UNITED STATES DEPARTMENT OF COMMERCE
Patent and Trademark Office

09/219,195 12/21/98 LEE F SA997115

Office Action Summary

DETAILED ACTION

SIMMONS ET AL'S FIGURE 3

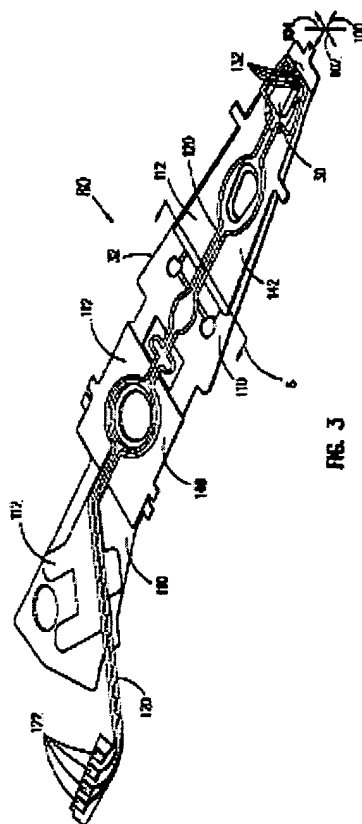
Simmons et al's suspension (32) is configured for in-line mounting of said slider/head assembly (30). See Simmons et al's Figure 3 shown on the following page.

Simmons et al's slider/head assembly (30) is orthogonally mounted onto said suspension (32). See Simmons et al's Figure 3 shown on the previous page.

Simmons et al's suspension (32) is configured for in-line mounting of said slider/head assembly (30). See Simmons et al's Figure 3 shown on previous page 6 of this office action.
